**Ashton Coal Project (DA309-11-2001-I)  
Extraction Plan for Longwalls LW205 – LW208**

## ATTACHMENT A

### Reasons for Approval of Extraction Plan for Longwalls LW205 – LW208

Figure 1: Longwall Layout in Upper Lower Liddell Seam

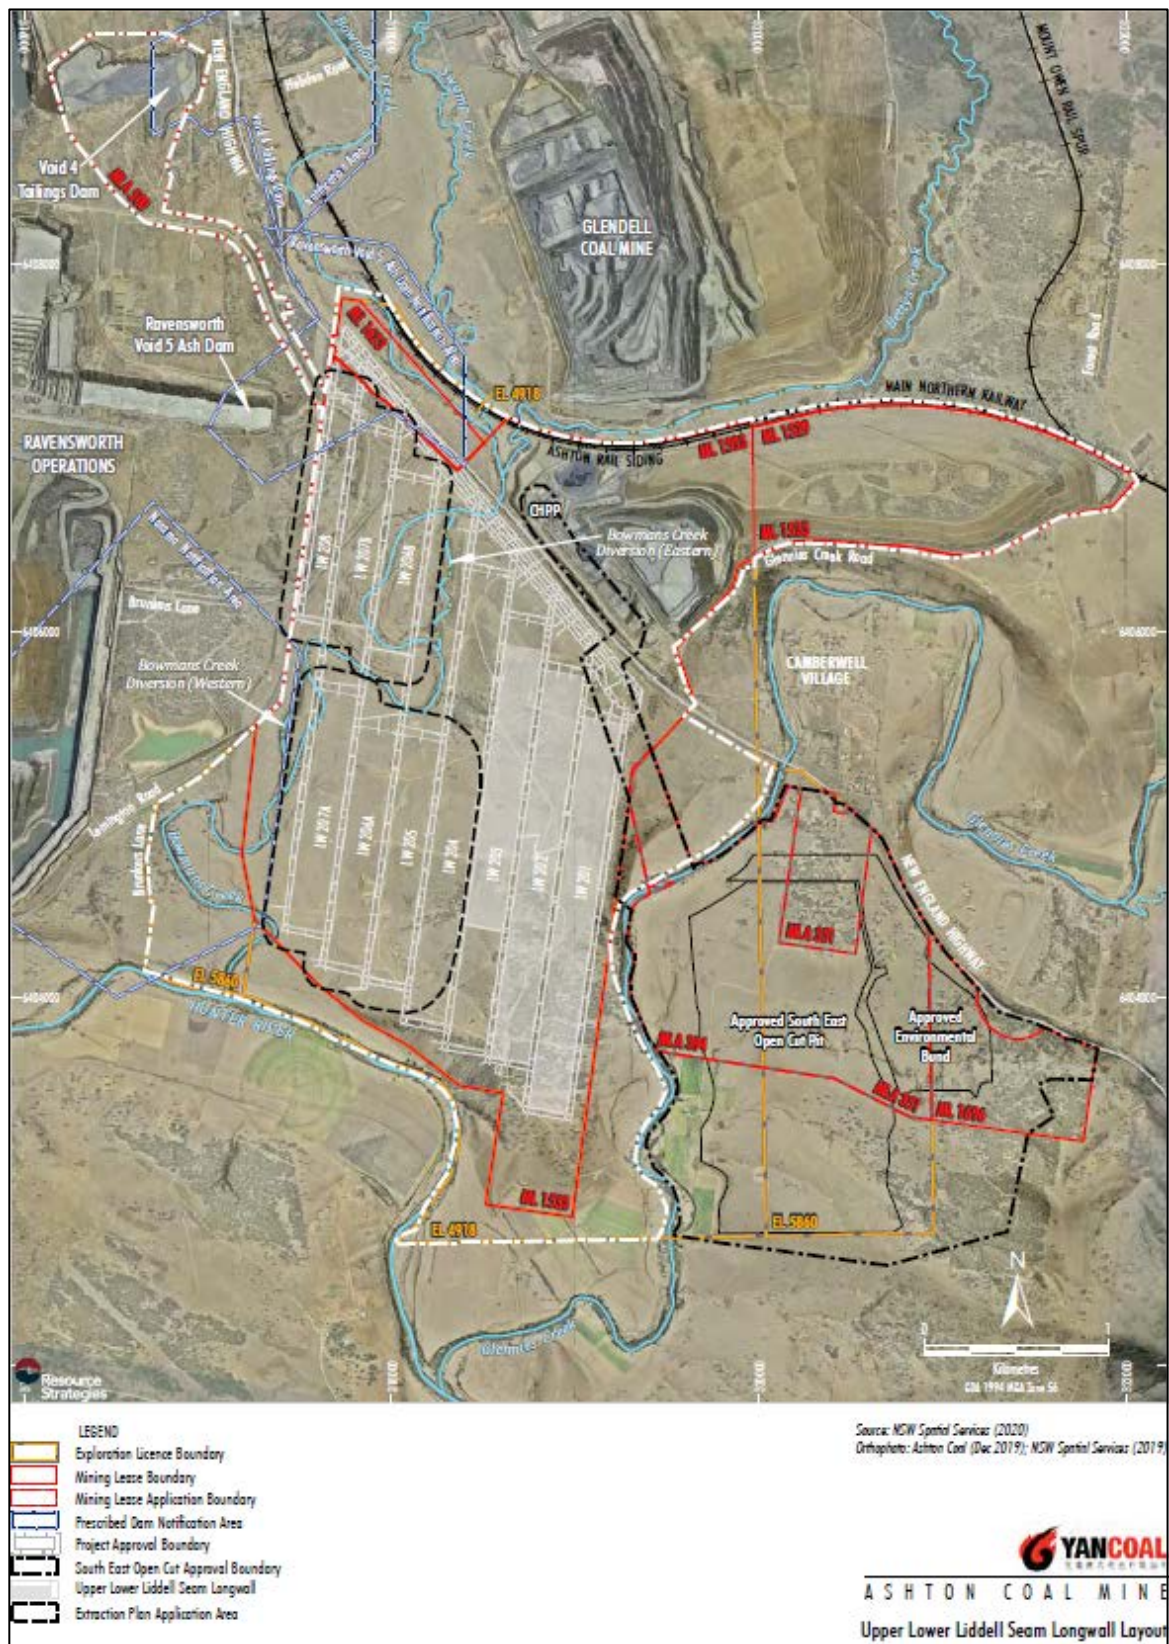
4. The mining domain included in the current EP (**Figure 1**) is split into the northern (LW206B, LW207B, LW208) and southern (LW205, LW206A, LW207A) longwall blocks designed to avoid directly mining under Bowmans Creek.
5. The panel lengths range from 957 m (LW206B) to 1,343 m (LW205) and the void width for majority of longwalls would be 215.4 m except for LW208 where the void width would be 124.0 m. The extraction height would be typically in the range 2.5 m to 2.7 m with an average extraction height of 2.6 m for all longwalls. The minimum chain pillar width would be 24.5 m for majority of longwalls except LW208

8. The EP Area shown in **Figure 1** represents the area likely to be affected by the mining of LW205 to LW208. It is the surface area enclosed by the predicted limit of vertical subsidence from these longwalls and is based on an angle of draw of 26.5° or 0.5 depth to the ULLD seam from the outermost goaf edge of all panels in all seams at the mine.

**Figure 2:** Built Features within the Extraction Plan Area

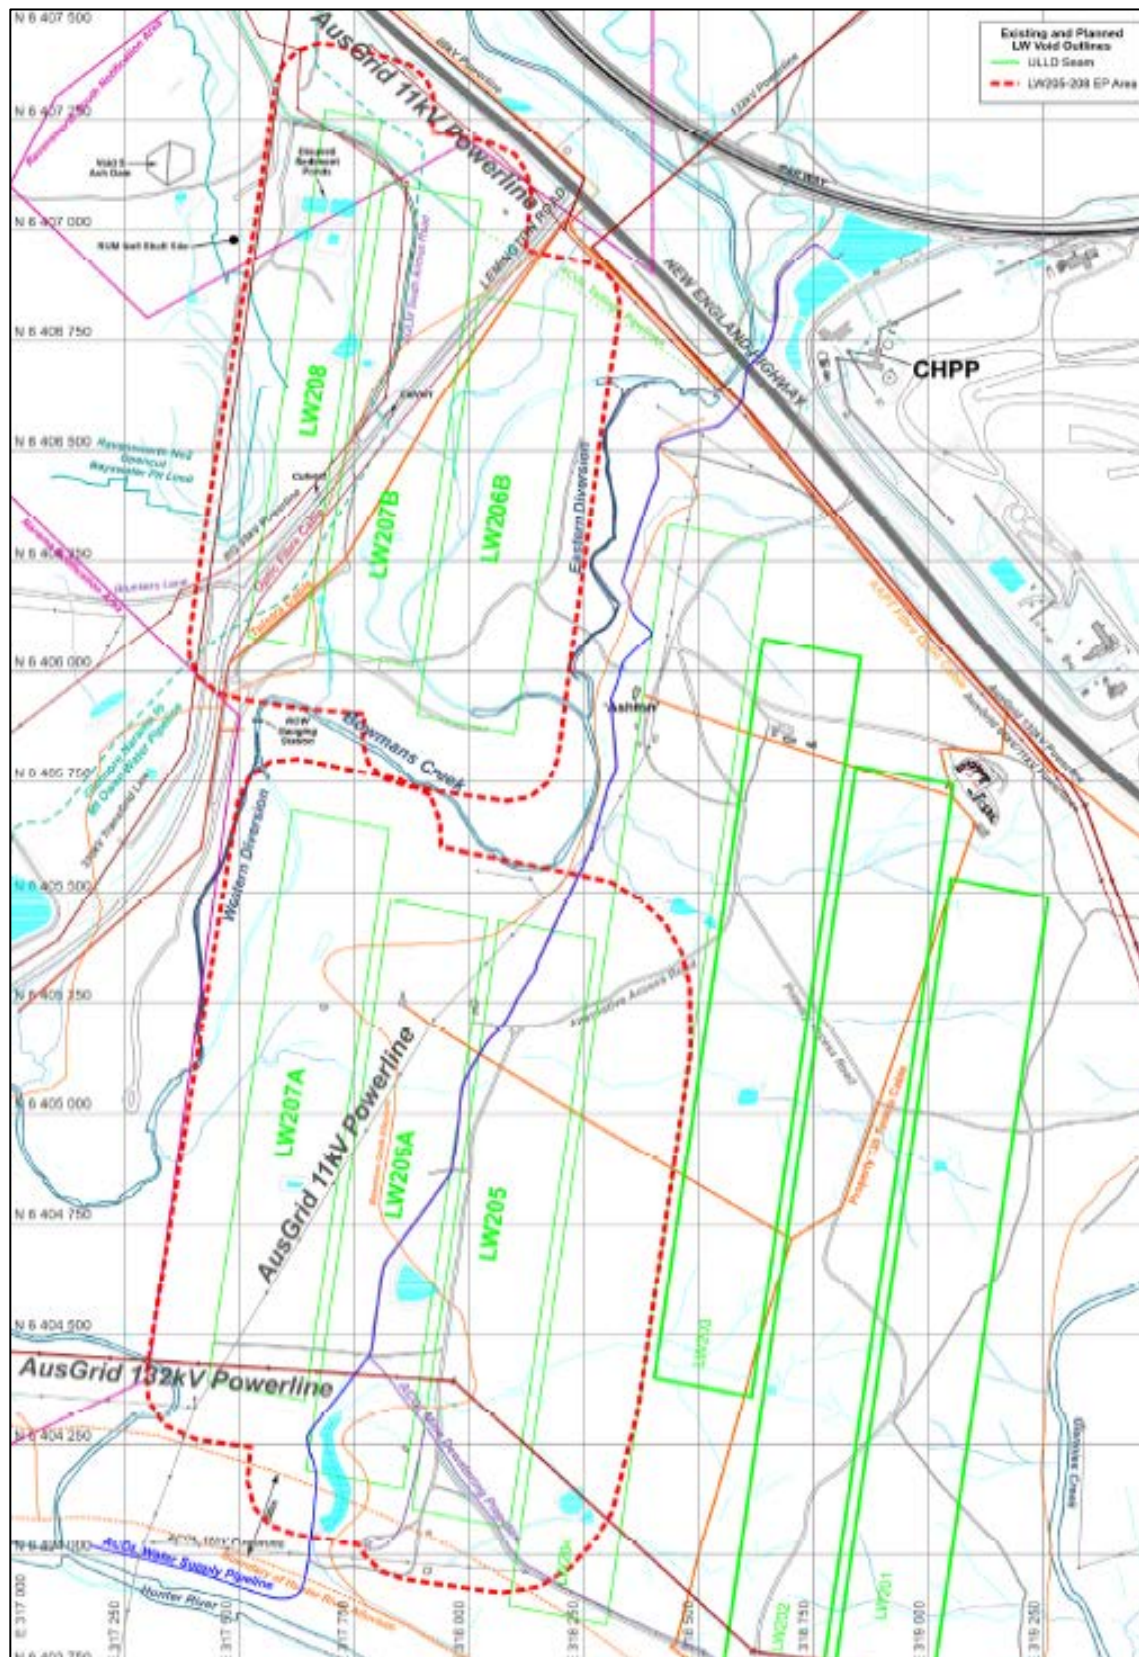
10. Natural and built features shown in **Figure 2** have the potential to be impacted by subsidence from the extraction of LW205 – LW208. These impacts range from a change in the landform, surface cracking, ponding to impacts to built features with the potential to render them unserviceable.
